Optimization Review
Jones Road Superfund Site
Harris County, Texas

Report of the Optimization Review

August 01, 2014

Figure 3: Cross-section of mass distribution in shallow source soil. Majority of site mass is located in Shallow Soil near and beneath shopping center.

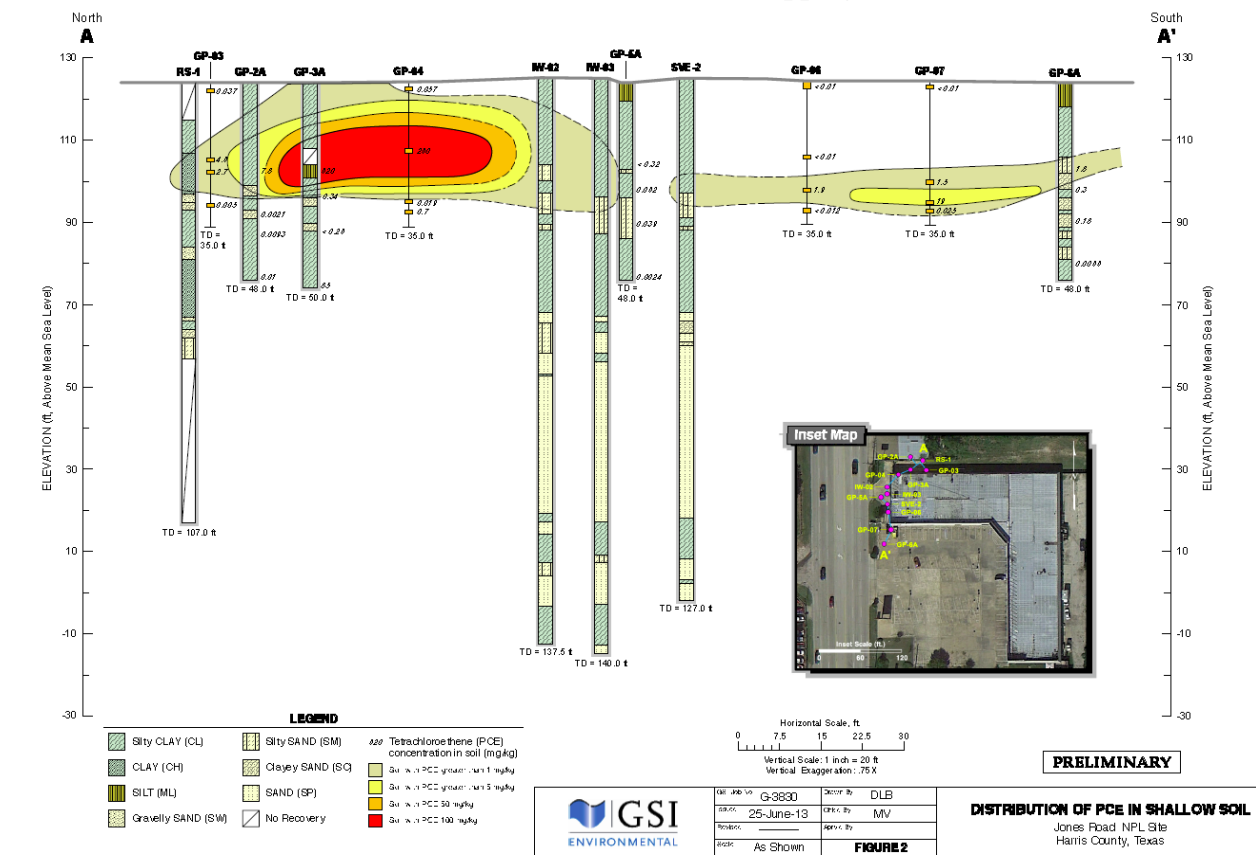
SVE is recommended for the shallow clay soil in the area immediately behind and beneath the shopping center, focusing on the area around the SVE-01. Although the Shallow Soil has fairly low permeability, SVE may be a viable remedy in the limited area of highest contaminant mass (see Figure 3). Based on the continued use of the shopping center and the limited access to the area of high contamination (in an alley behind the shopping center and below the building), excavation or thermal treatment are not practical. SVE may not fully remediate contamination in this zone, but would serve to address an area of highest residual contaminant mass and, therefore, limit migration to the Shallow WBZ, indoor air and deeper strata.

Recommendation 5.2.1: Pilot test an SVE system in the Shallow Soil source area in the vicinity of SVE-01, behind the shopping center, near former boring GP-04. An illustration of the zone of high contaminant mass to be targeted by the Shallow Soil SVE is provided in Figure 3. If the pilot test demonstrates that an SVE system can effectively remove contaminant mass, design and install a Shallow Soil SVE system to address contamination in the Shallow Soil.

The additional system is anticipated to include four to five new SVE wells installed to a depth of approximately 30 to 35 feet bgs, screened from the surface to 25 feet bgs in the alley behind the shopping center, between existing wells MW-02 and MW-03. An air injection (AI) process is anticipated to be part of the design, but precise design specifications will be developed by Region 6 and the Response Action Contractor (RAC). SVE may have a limited area of influence in the clay of the Shallow Soil; therefore, SVE wells may be placed more densely here than in more permeable strata. Remedy performance will be measured by contaminant mass removal in the vapor effluent.
